Barangaroo South - Stage 1a Public Domain Works Excavation Works (SSD 6303), Hickson Road, Millers Point

2 September 2014

**Re: Barangaroo South - Stage 1a Public Domain Excavation Works (SSD 6303),
Hickson Road, Millers Point**

Title	STAGE 1A - INTERNAL WORKS SUBGRADE PLAN SHEET 4
Drawn By	JB
Designed	MH
Checked	
Approved By	
Date	MAR'14
Scale	1:200
Project No.	161803
Site No.	B10
Drawing No.	CD0000023
Revision	03

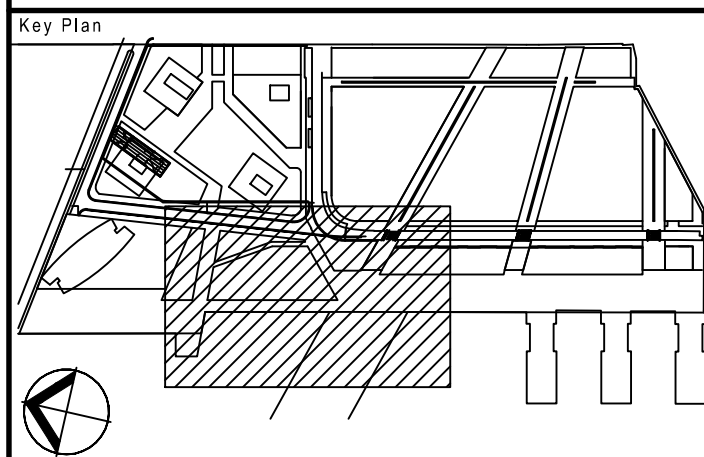
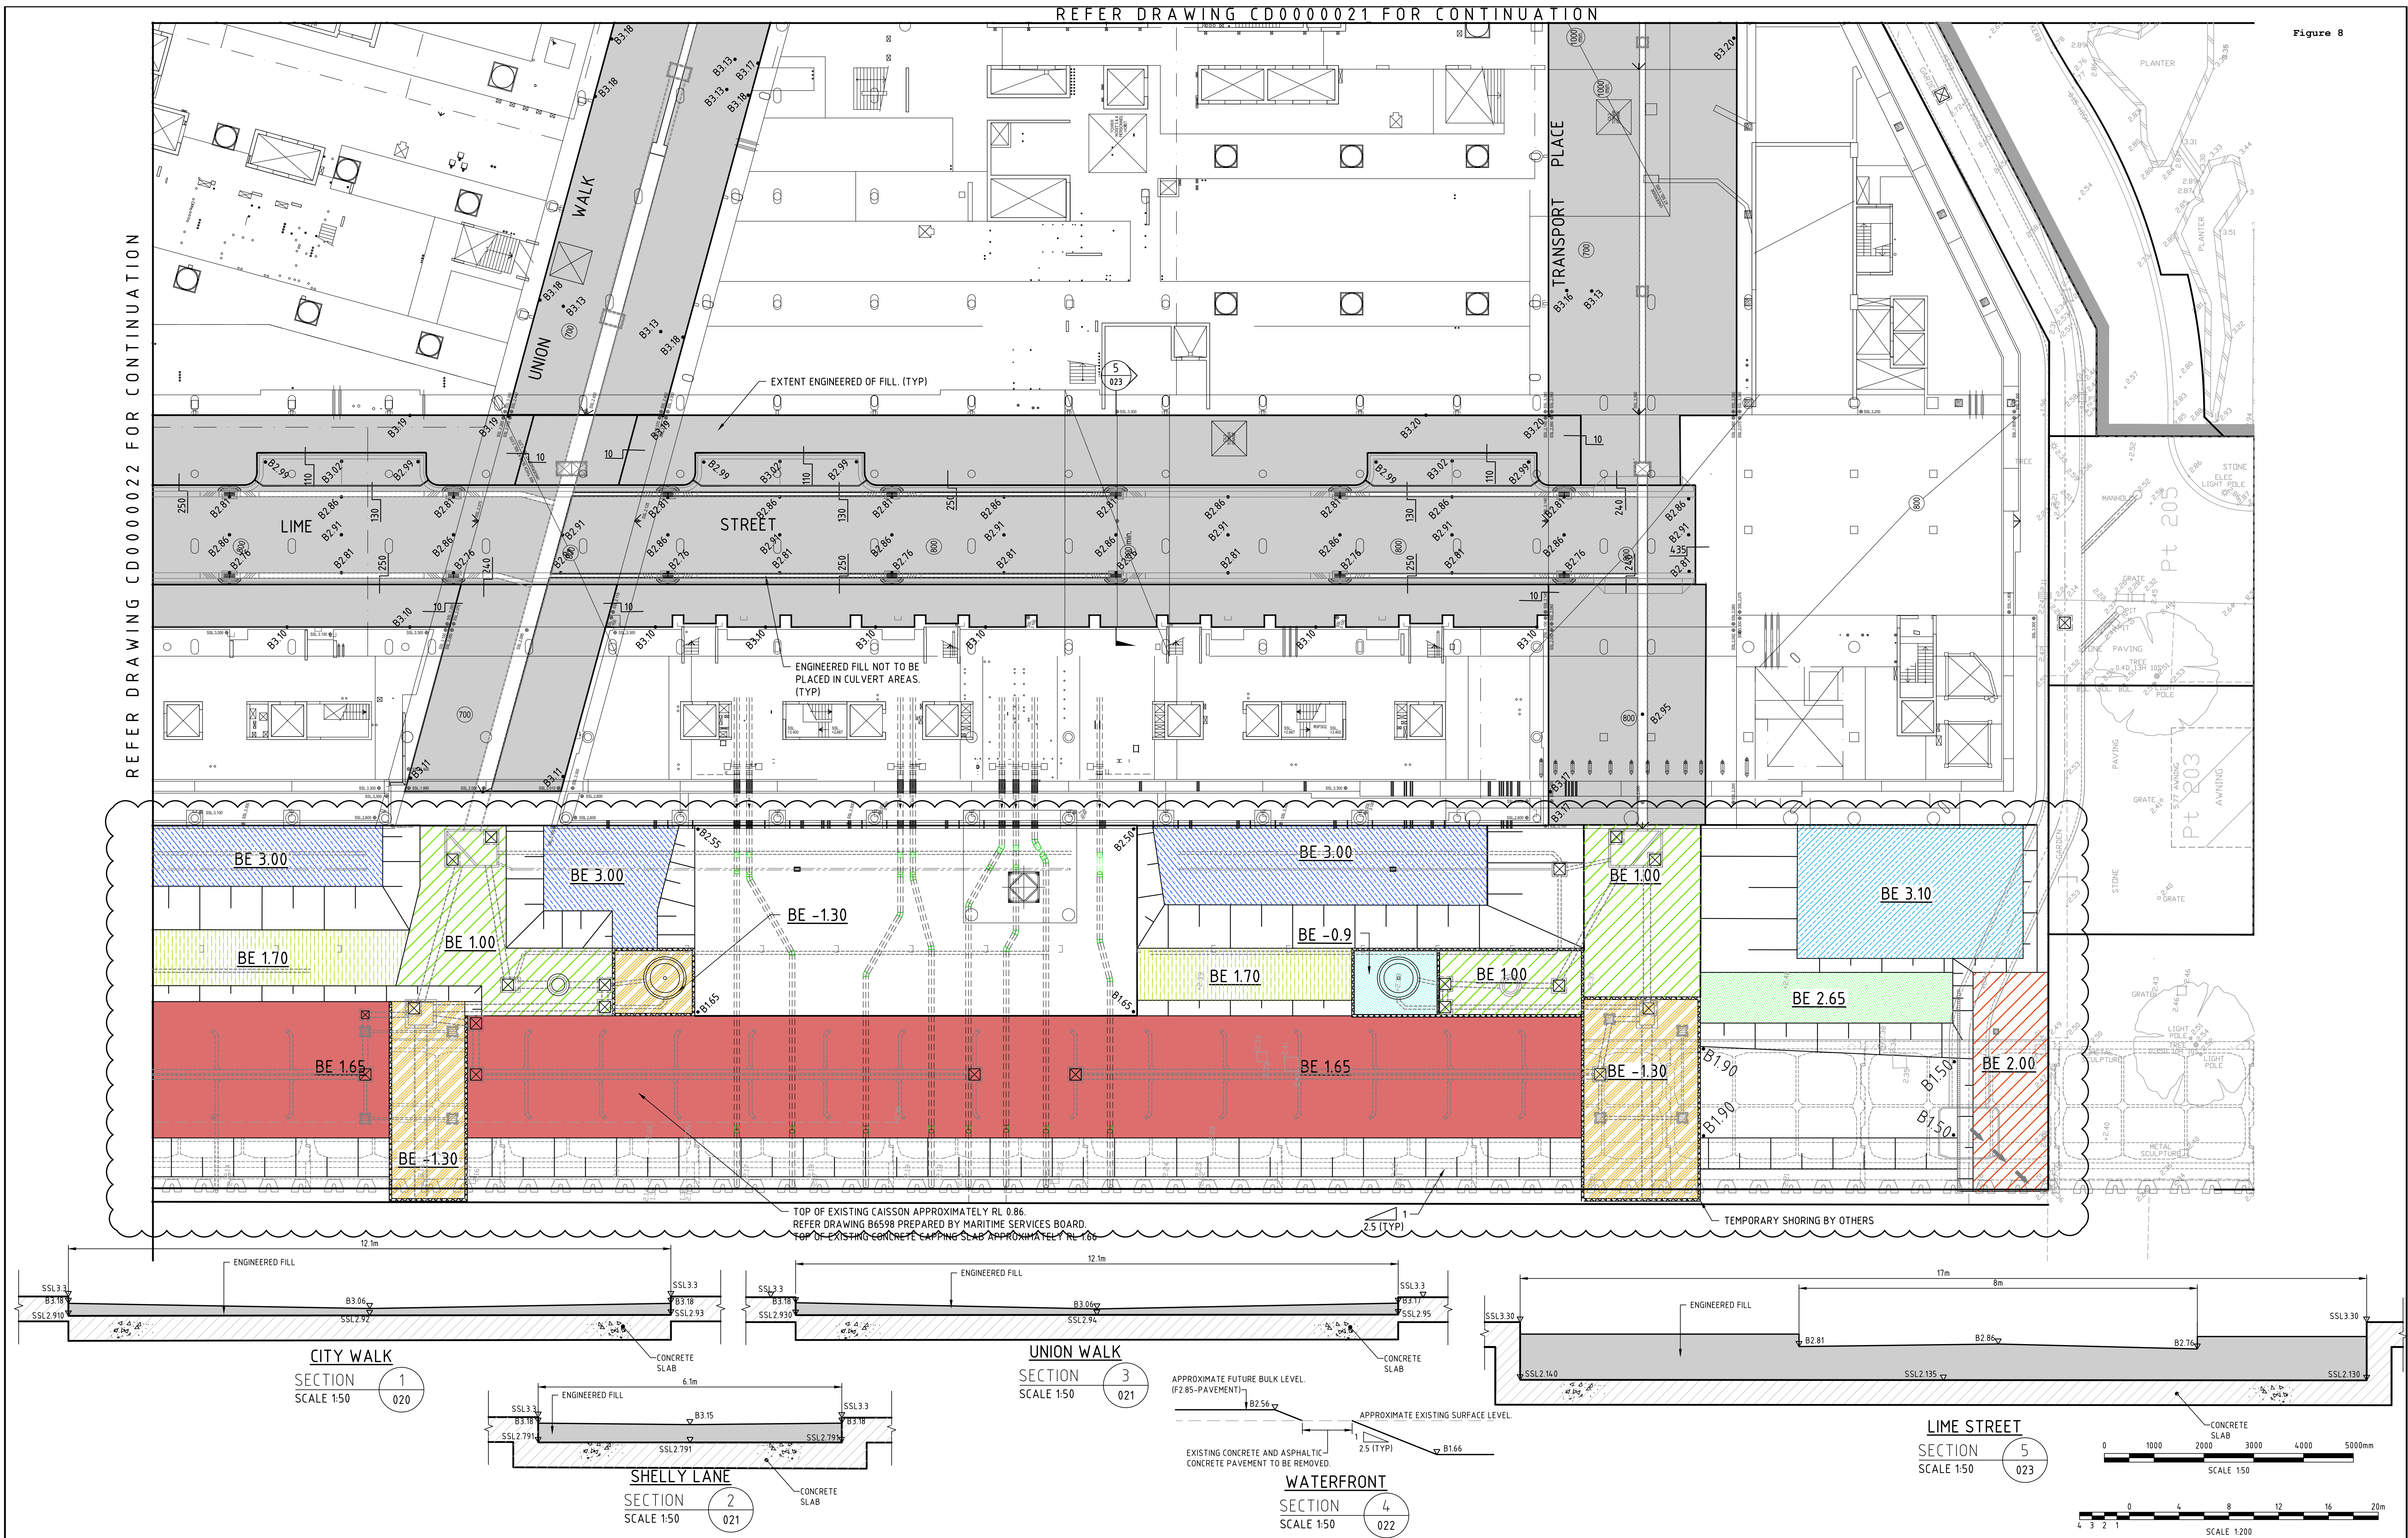
- The shallow excavation will extend to an approximate Relative Level (RL) of 1.65 m Australian Height Datum (m AHD). Based on the current slab level (which is at approximately RL 2.2 m AHD) excavations below the 0.2 m thick slab will generally be limited to approximately 0.35 m of soil. Some limited areas will be excavated to approximately RL -1.3 m AHD (i.e. approximately 3.3 m below the underside of the 0.2 m thick slab) (refer to **Figures 7 to 8**);
